SEATING LAYOUT	
FOR: BUDWEISER EVENTS CENTER	
LOCATED: LOVELAND, CO.	
DATE: 08/19/02	SCALE: 1/8"=1'–0" FLOOR IS CONCRETE
DRAWN BY: John Wellman	CHECKED BY:

NEENAN
This submittal has been reviewed for conformance with the contract documents. All final verification and coordination of dimensions and quantities is the responsibility of the subcontractor.
Spec: 12-620 Sub No: 001-02
By: CK Date: 5-1-03

LARIMER COUNTY FAIRGROUNDS
LOVELAND, CO.

PLAN/ELEV.		DWG. NO. T02049BA	
SCALE: 3/32" = 1'-0"	DATE	REVISION DATE: 4/21/03	REV.
DRAWN BY: CW	8/14/02	LAST PLOT DATE:	C
CHECKED:		CAD FILENAME: T02049BA_REVC.DWG

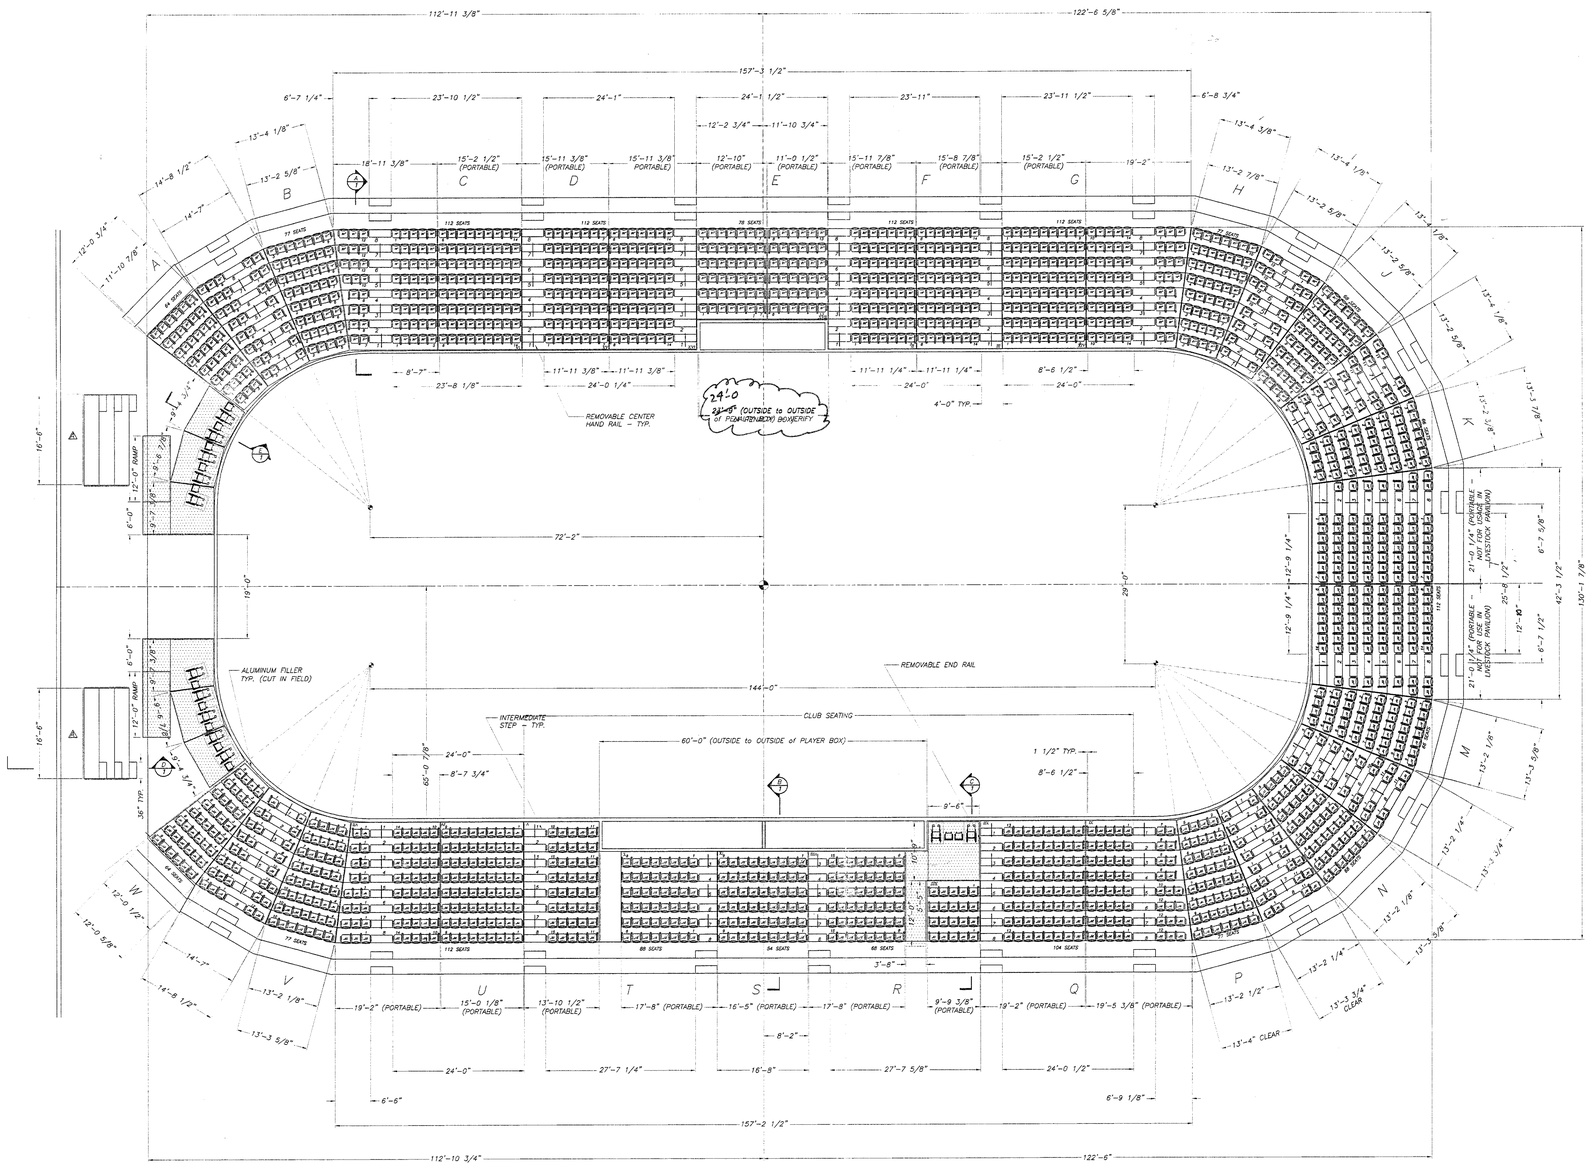
ALL RAILS TO MATCH ARCH DETAILS
SEE ATTACHED SHEETS
A1.9.10 & A.1.9.14 → A1.9.17
PROCEED ACCORDINGLY
~~PROVIDE FULL SET WITH ARCH SEAL~~

PROVIDE THIS SECTION PROGRAMMABLE @ ROW 4 AS WELL - OPERATOR MAY ELECT TO REDUCE ADA PROVIDED WIDTH IN FIELD
